SUBJECT: KEWAUNEE NUCLEAR POWER PLANT - REQUEST FOR EXEMPTION FROM
THE REQUIREMENTS OF 10 CFR PART 50, APPENDICES G AND H, AND
10 CFR 50.61 (TAC NO. MA8585)

Enclosure: NRC Staff Method Evaluation

NRC STAFF METHOD EVALUATION

Figure 1 - Current KNPP RPV Cooldown P-T Limit Curves Through 28 EFPY

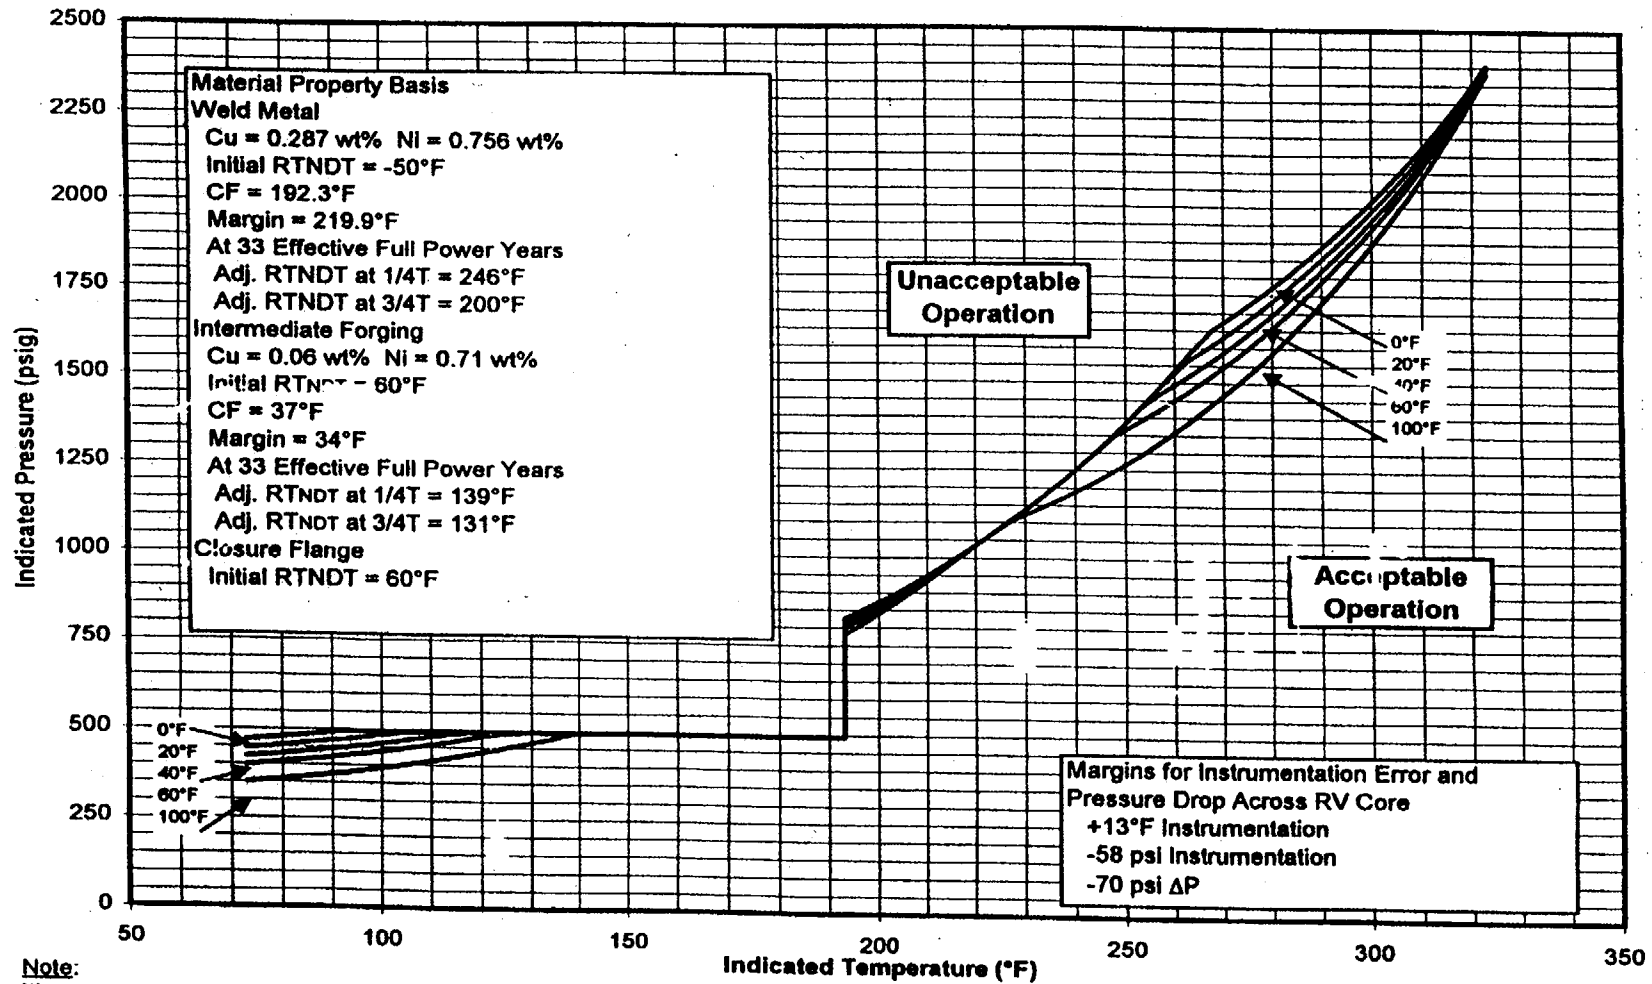
However, the NRC staff did note that in the NRC staff SE which granted approval for the current KNPP P-T limits, a restriction on their validity to 28 EFPY of operation was imposed because the NRC staff calculated the cooldown curves in Figure 1 to be 5 to 7 °F non-conservative at 33 EFPY.^[31] This was based on the NRC staff's conclusion that the EOL 1/4T and 3/4T reference temperatures for the KNPP RPV circumferential weld (under the Charpy V-notch and drop weight-based methodology) would be 256 °F and 210 °F, respectively. Reestablishing the EOL 1/4T and 3/4T reference temperatures as 247 °F and 196 °F, respectively, using the NRC staff's Master Curve-based approach, "corrects" for this 5 to 7 °F non-conservatism in the current KNPP cooldown P-T limit curves and would justify, if requested by the licensee, their use through 33 EFPY of operation. The NRC staff's prior conclusion, that the other current KNPP P-T limit curves (e.g., the heatup limit curves, which were based on the material properties of the most limiting KNPP beltline forging and the limiting RPV closure flange material) would be acceptable through 33 EFPY, remains valid.

Figure 3 - Plot of Available Data Sets Containing Both PCVN and 1T-CT or Larger Data to Estimate the Bias in PCVN T_0 Results as a (Potential) Function of the Constraint Parameter, M_0 for the PCVN data set.

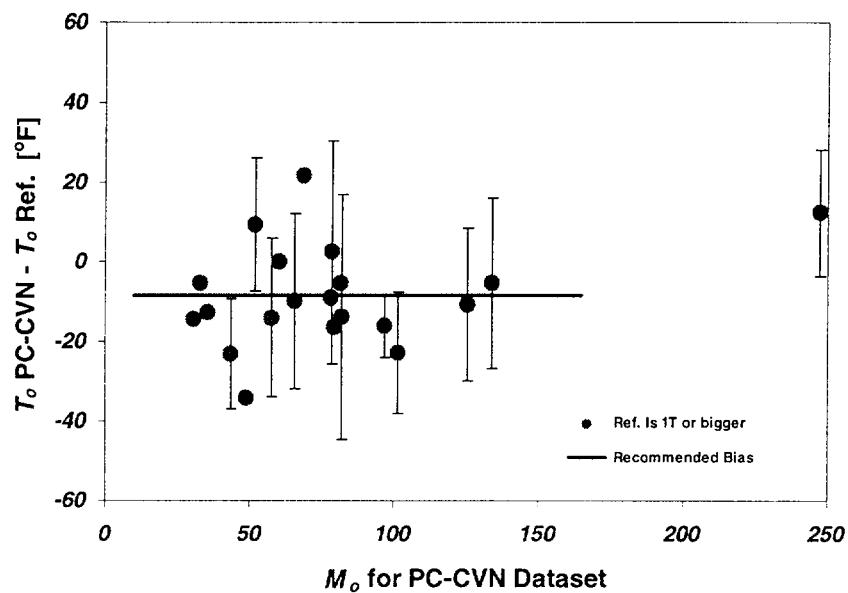
In Figure 3, " T_0 PC-CVN" is the T_0 value determined for a particular material based upon the testing of PCVN specimen sets per ASTM E1921-97 (including the censoring limit) and " T_0 Ref." is the T_0 value calculated for the same material from larger specimens. Thus, the ordinate axis in Figure 3 represents the difference in calculated values of T_0 with negative values indicative of a potentially non-conservative bias in the T_0 value determined from the PCVN data set. This T_0 differential was then plotted relative to the constraint parameter, M_0 , which is the non-dimensional deformation level associated with K_0 , the 1T equivalent K_{JC} value associated with the 62.3 percent cumulative failure probability from the data derived from the

From Figure 3, the NRC staff concluded that although a statistically significant bias of 8.5 °F was evident in the data, no defined trend with M_0 was able to be resolved. The NRC staff also observed other data points for which " T_0 Ref." values could be calculated from specimens as small as 0.5T-CTs. With the inclusion of this additional data, a trend of increasing PCVN bias with decreasing M_0 may have been resolvable, but the complication of including data wherein the size (and thus the expected constraint) of the specimens used to define " T_0 Ref." was nearly the same size as the PCVN specimens would have made any such conclusions highly speculative. It can, however, be noted that with regard to addressing bias related to the licensee application, either interpretation would have yielded the same net effect in the NRC staff's overall methodology.

The NRC staff acknowledges that the lack of a definable trend in Figure 3 calls into question whether the observed bias from PCVN test results can be simply addressed as a matter of specimen constraint. Other theories have been postulated, including consideration of specimen geometry and T-stress, to explain the observed differences in PCVN and CT specimen results. The NRC staff recognizes that additional research in this area may help to better define this issue and modify the conclusions of this SE. However, the NRC staff concludes, at this time, that the assumption of a 8.5 °F bias in PCVN-based T_0 values relative to values obtained with larger size CT specimens, to be applied to each unirradiated and irradiated PCVN data set in the licensee submittal, is adequate to address this potential source of non-conservatism in the NRC staff's methodology as developed in Appendix A to this SE.
